MEMORANDUM

Project: Pinot Glen -
PDG No. 131-035

RE: Applicant's Open Record Period #1 Submittal for Casefile No.
LU 2025-012 SUB

Figure 2. Post-Hearing Site Plan

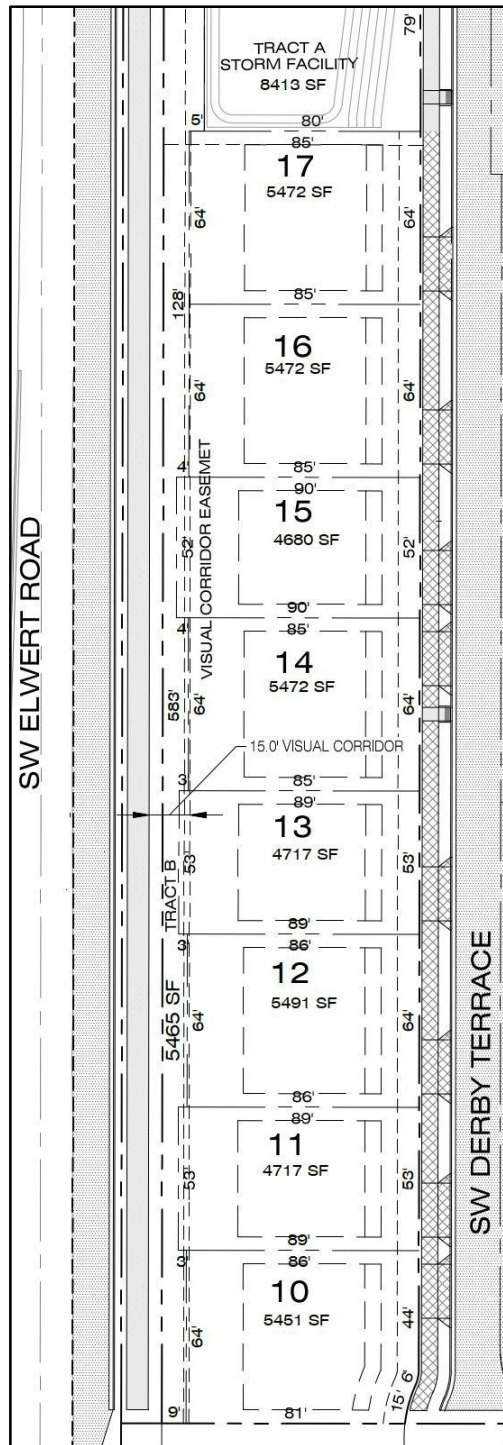
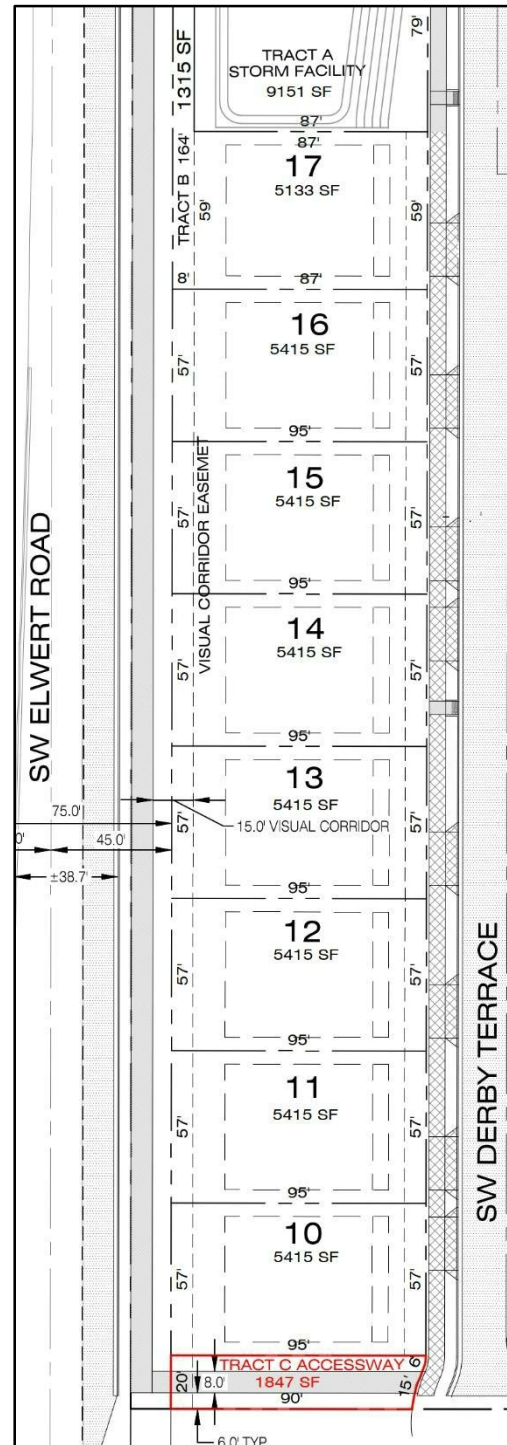
P1.0 – Preliminary Plat, the Applicant has made minor revisions to Proposed Lots 10 through 17 to facilitate the creation of “Tract C”, a 20-foot-wide pedestrian tract including an 8-foot paved pedestrian trail, south of Proposed Lot 10.

Figure 3. Pre-Hearing Open Space

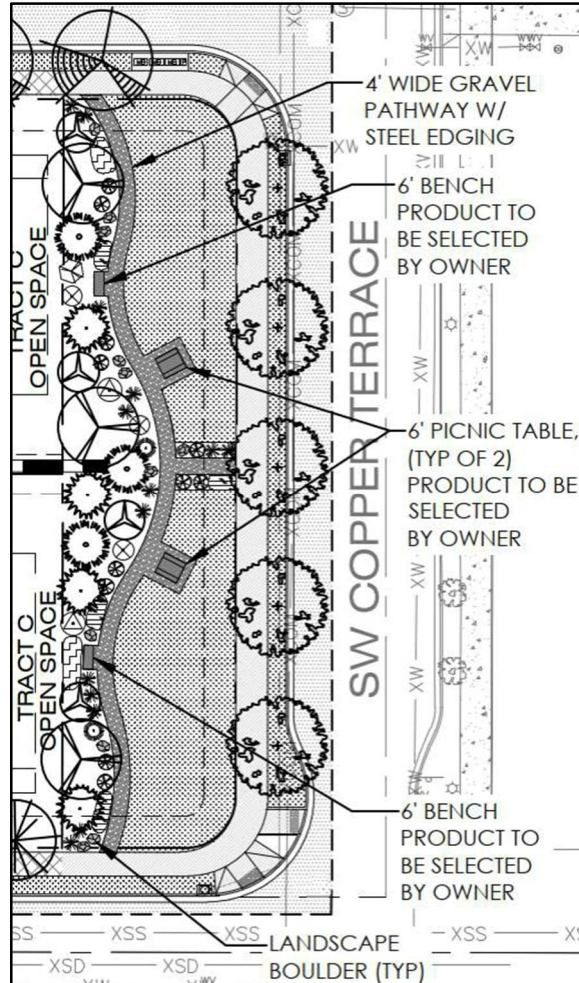
While the Applicant believes that the proposed open space meets the requirements of SZDC Section 16.140.030 and is approvable as proposed, they have also heard a stated preference from the City to have the open space located more centrally within the development, and therefore moved away from the street to the extent practicable. Accordingly, the applicant requested this open record period to investigate the possibility of relocating the open space, and the impact of associated ripple effects across the development site.

In investigating the change, the applicant proposes moving the open space area west within the same block. The relocated open space will be similarly landscaped with a variety of trees, shrubs, and groundcovers, and grass areas for picnics and recreational play, along with a meandering walking path and seating options. Due to adjustments to the site plan described in this submittal, the calculations for lot averaging and the provision of open space have been revised below. However,

Revised Plan Sheet P1.0 – Preliminary Plat
Modification Request 1 – Intersection Spacing
Modification Request 2 – Cereghino

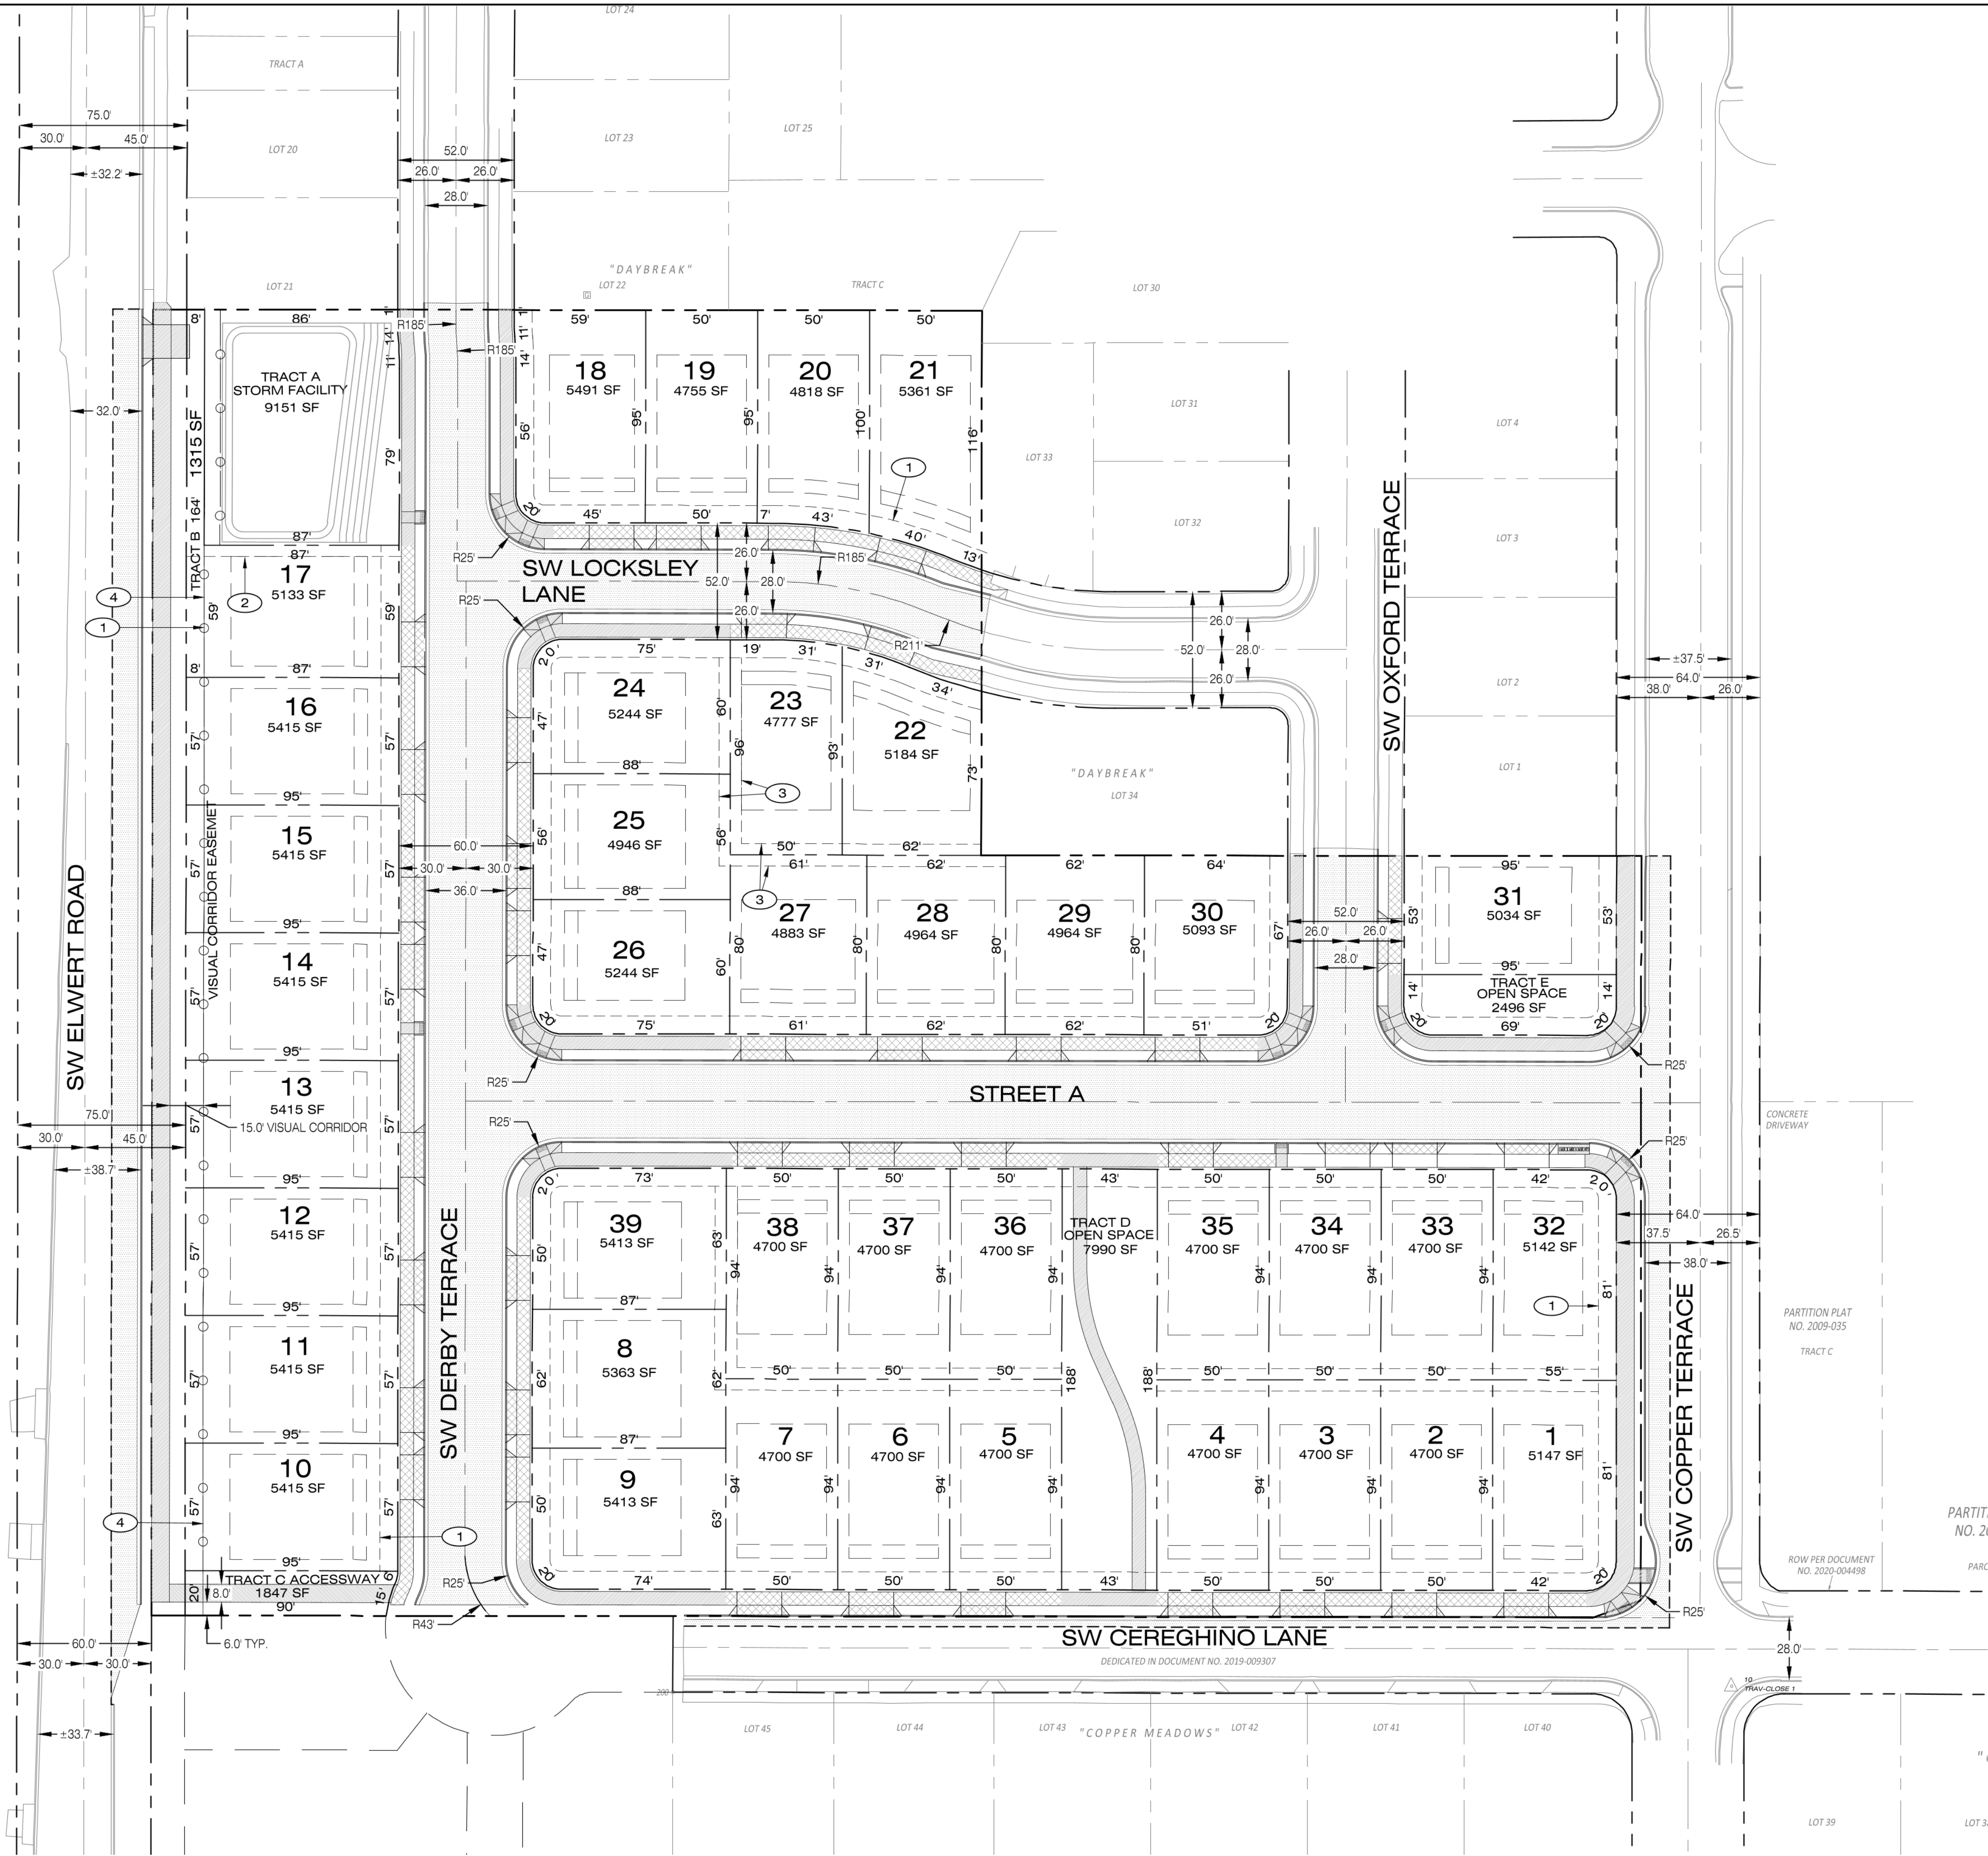
RESPONSE: As above, the applicant has provided a bicycle and pedestrian connection on what is currently Lot 10. However, lighting is not shown on the Feeder Trail section and should be removed. The Sherwood Engineering Design Manual, Section 420.10 states that *Lighting for shared-use paths is important and should be considered for shared-use paths serving commuters, providing access to transit stops, and at highway intersections. Lighting should also be considered through underpasses or tunnels and when nighttime security could be a problem.* None of the conditions listed above as warranting consideration of lighting exist at this location. The proposed trail section is approximately 100 feet long, straight, and lit at both ends by street lighting such that each end will be visible from the other.

Proposed Prior to Final Plat Approval, submit plans including a bicycle and pedestrian connection between SW Derby Terrace and SW Elwert Road, as shown on Revised Sheet P1.0 – Preliminary Plat, including concrete paving and landscaping.

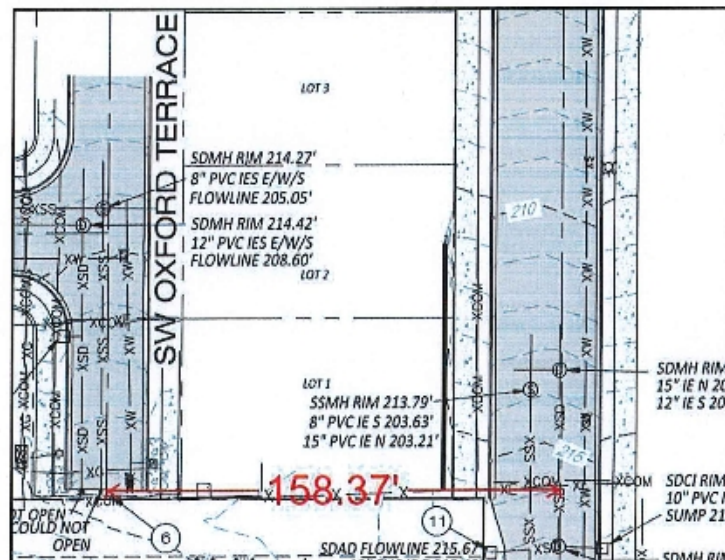
The applicant is required to extend existing stub streets abutting the site, and as such a connection to SW Oxford Terrace must be made. The existing street stub of SW Oxford Terrace, as it exists today, is located approximately 159 feet west of SW Copper Terrace, as shown below:

The existing distance between intersections on SW Copper Terrace (SW Cereghino Lane, and SW Lionheart Lane) is 656 feet, therefore in accordance with SDZC Section 16.128.010 A.2., a connection is required between SW Copper Terrace and SW Derby Terrace to divide the block and provide blocks of less than 530 feet. The proposed location of the Street A connection is
